Proposal to revise the abrasion level of SRTT17S

Fig. Distribution of SRTT17S abrasion level (market assessment and 23-year test campaign)

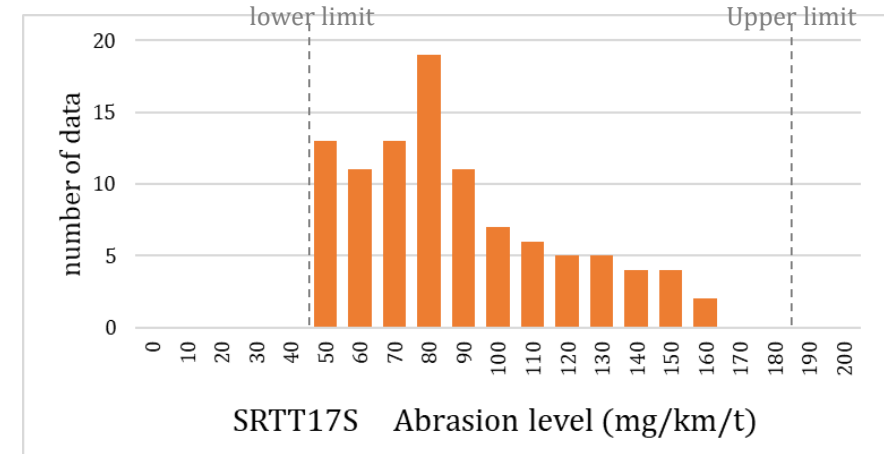
- All measurements met within the specified range (50g/km·t to 190g/km·t)
- There is a lot of data near the lower limit

- ▶ Concerned about nonconformity in actual operation
- ▶ The impact on Abrasion Rate Index was verified below the lower limit of abrasion level

【Proposal】 To Change the wear level of SRTT17S 45mg/km·t ~190mg/km·t

Fig. Relationship between SRTT17S abrasion level and Abrasion Index

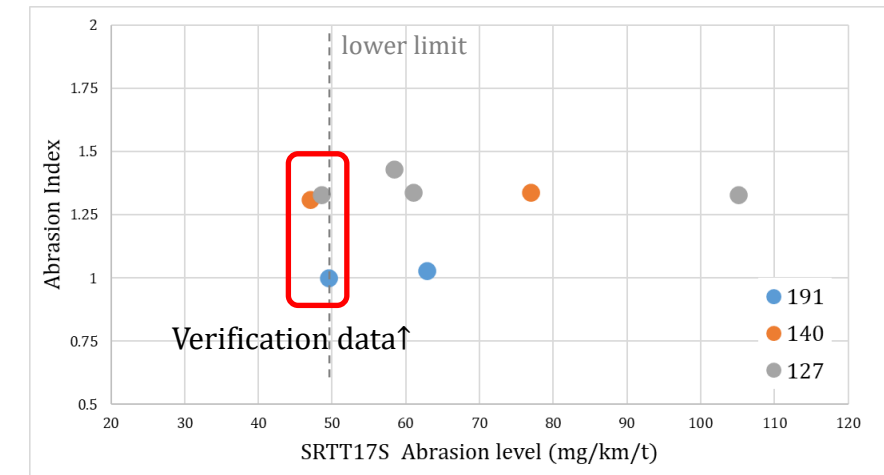
◆ Verification test Tested on sandpaper with over 20,000 km traveled.
 Compared to market assessment/correlation test results.

- Number of tests: 3
- Result: The results were not significantly different for all 3 SKUs.

- ▶ Minimal impact on the Abrasion rate Index
